TO: PCS Group Inc., Applicant
FROM: Julia Duncan, Associate Planner
DATE: May 24, 2022
SUBJECT: SUB21-073; Compark Village South Tract G Sketch Plan
SUB21-074; Compark Village South Tract G Preliminary Plan
Review Comments 03

COMPARK VILLAGE SOUTH TRACT A PRELIMINARY PLAN

COMPARK VILLAGE SOUTH
 LANDSCAPE PLANS AND
 MASTER STREET TREE PLANS
 PARKER, CO

COMPARK VILLAGE SOUTH
PARK FACILITIES MASTER PLANS
AND CONSTRUCTION PLANS
PARKER, CO

SHEET TITLE
PRELIMINARY PLAN COVER

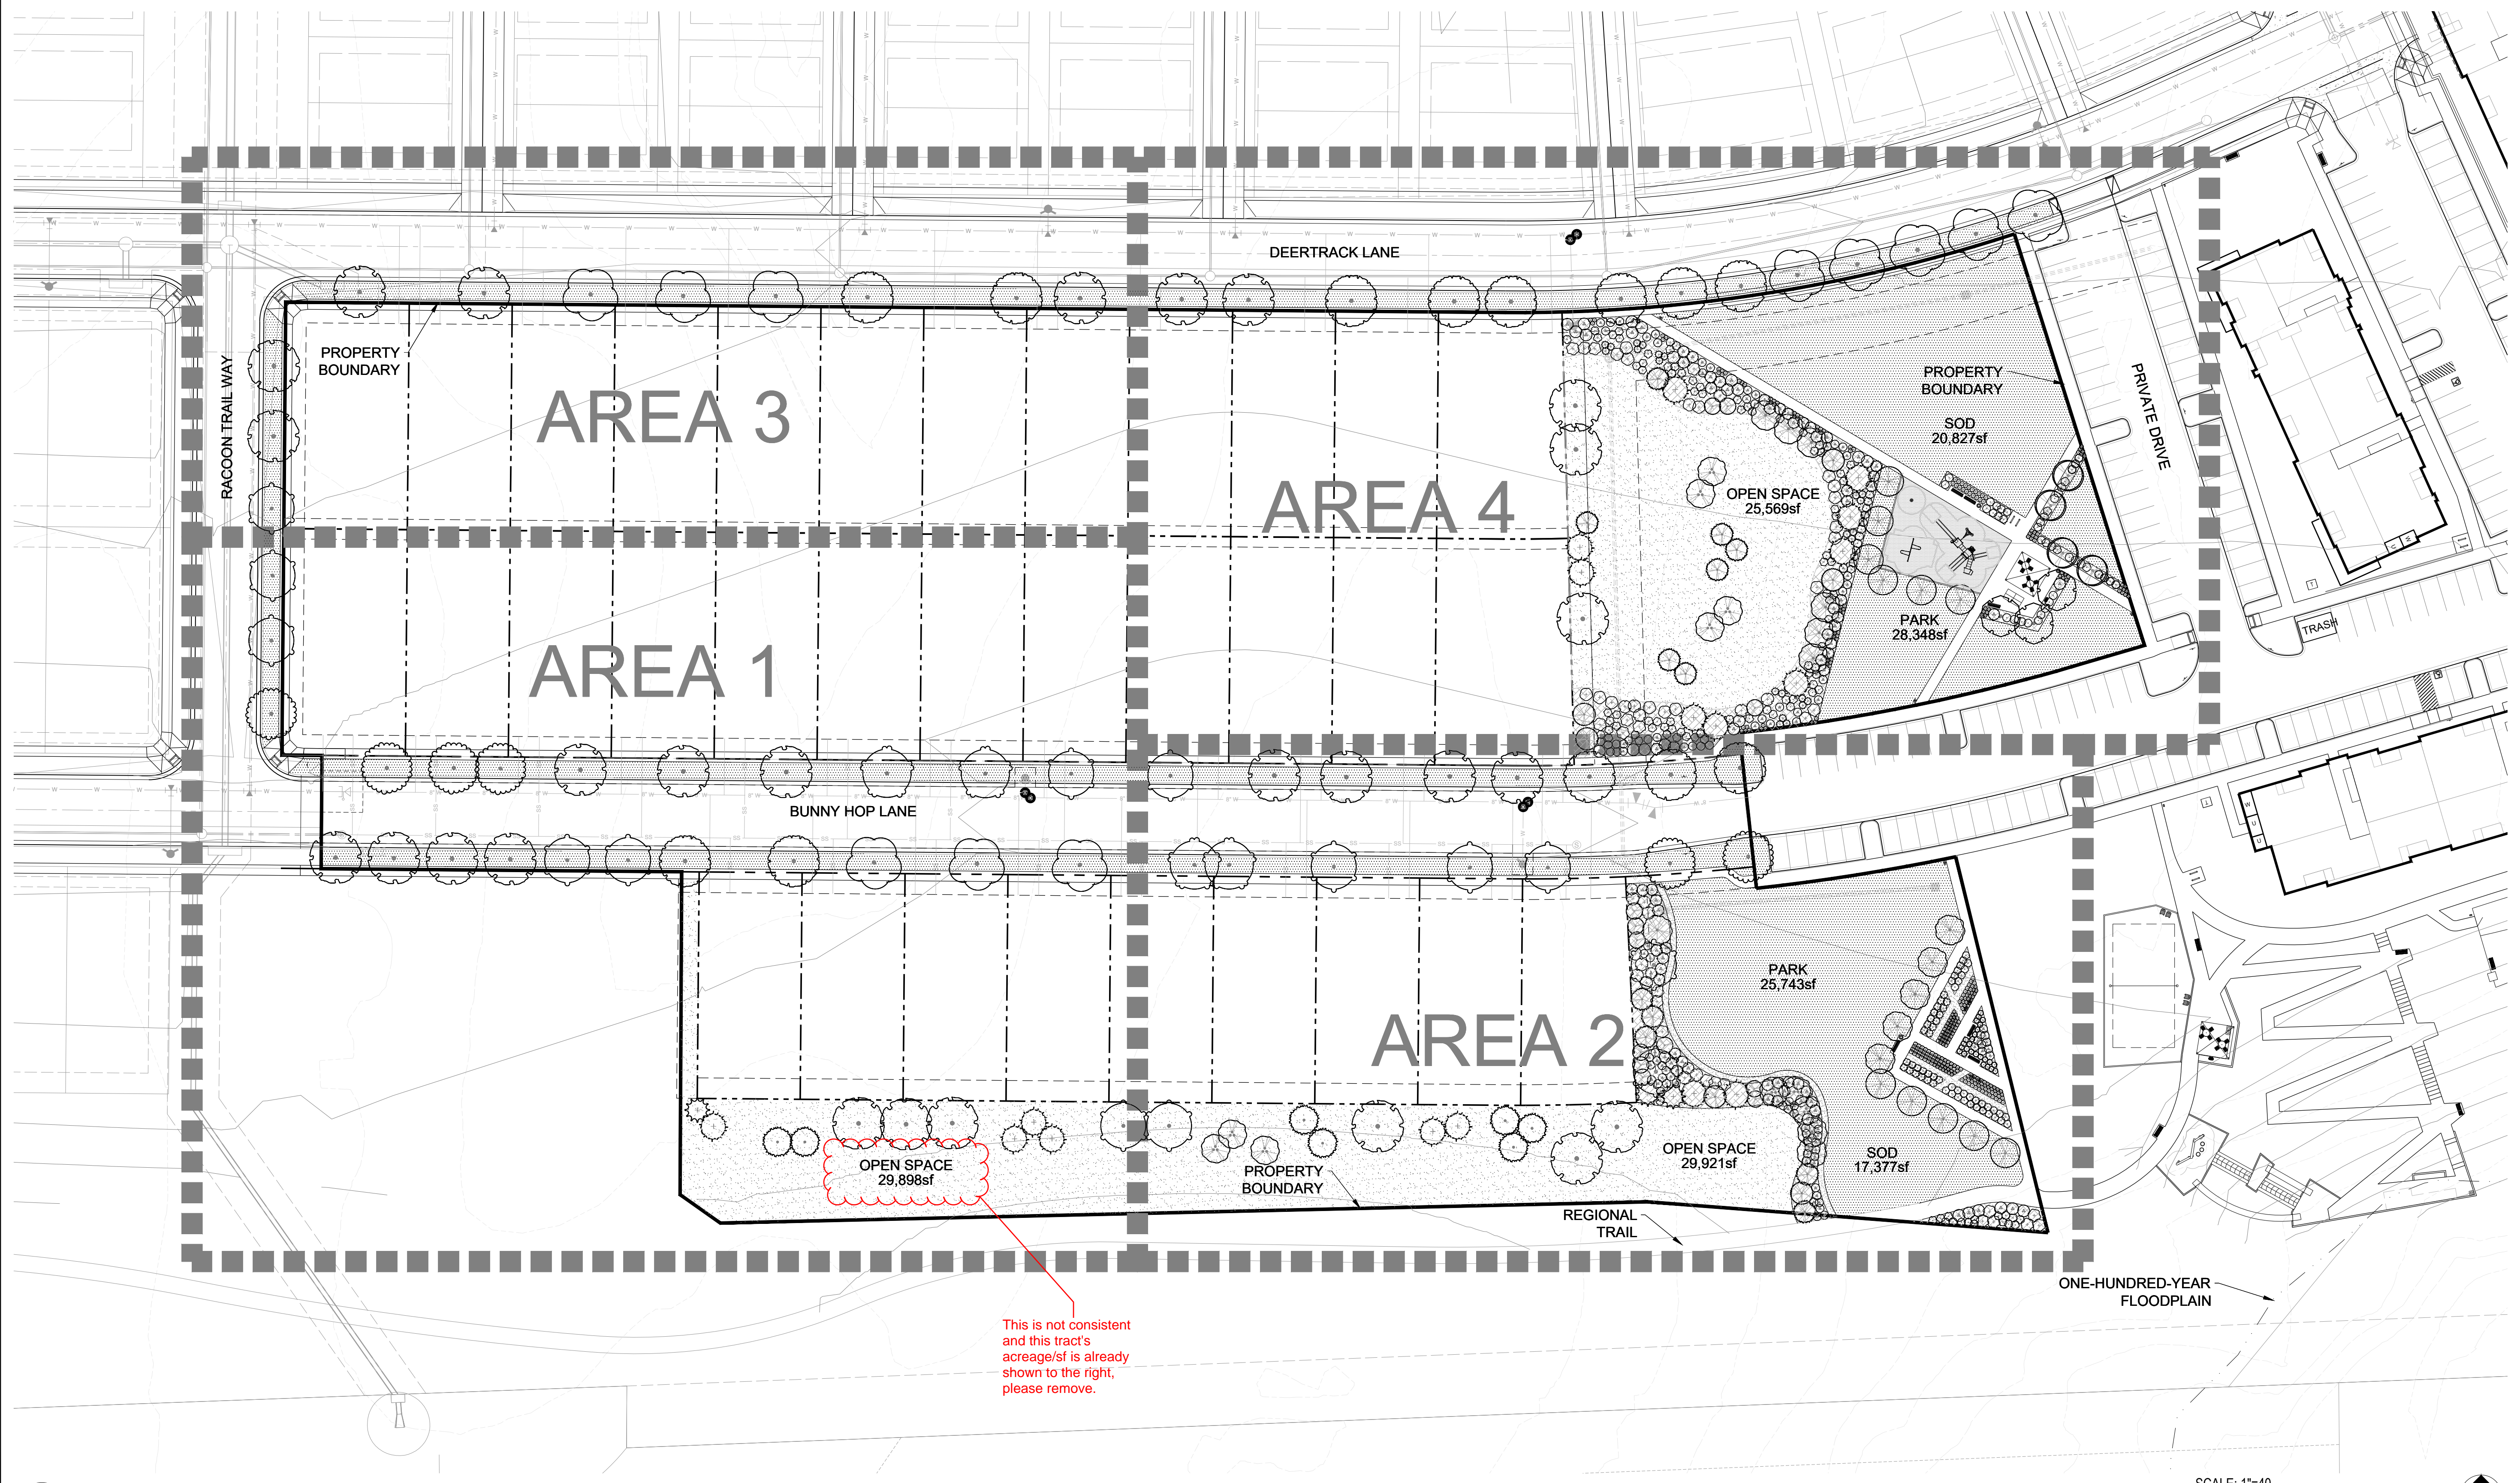
This is not the area of the tracts this is the total gross area. If you are going to have a subtotal here it should be the area of tracts A1-A5

This is not consistent and this tract's acreage/sf is already shown to the right, please remove.

■ Sheet Name ■
COVER SHEET
■ Sheet Number ■
1 of 7

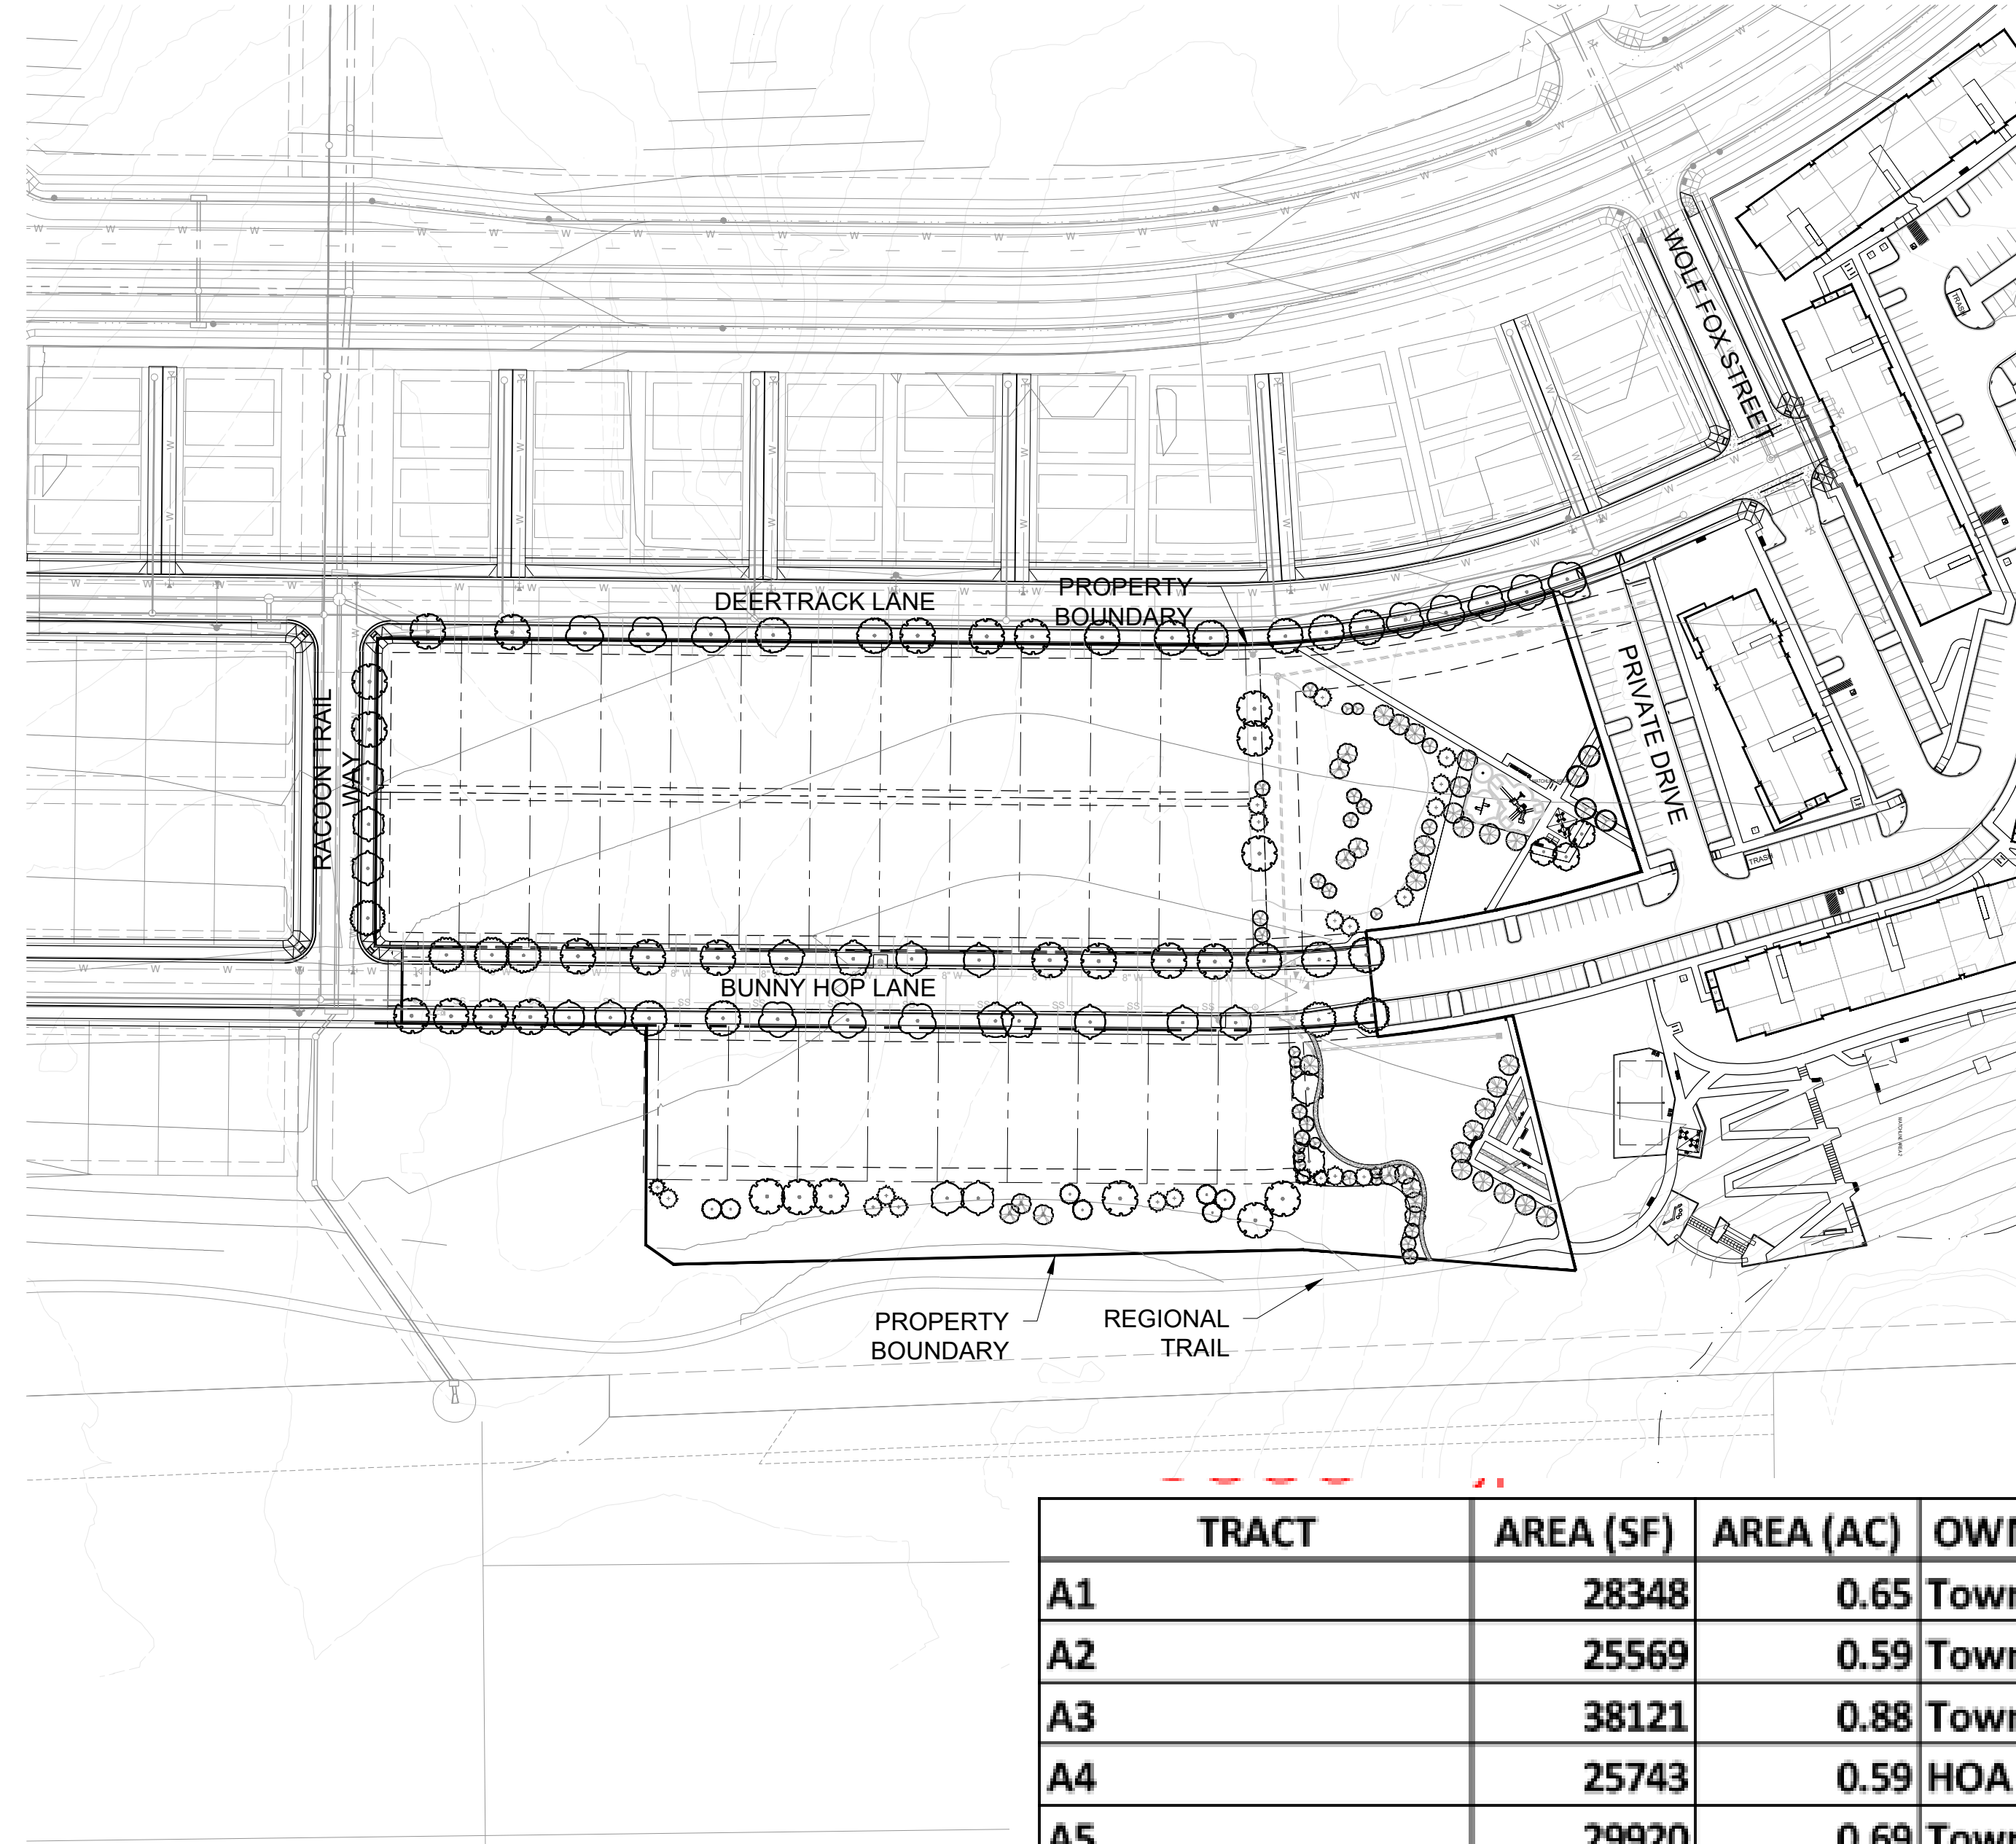
Please include this information on this cover sheet-this comment has been given in every review.

These numbers don't match what you are showing on your Prelim Plan for parks
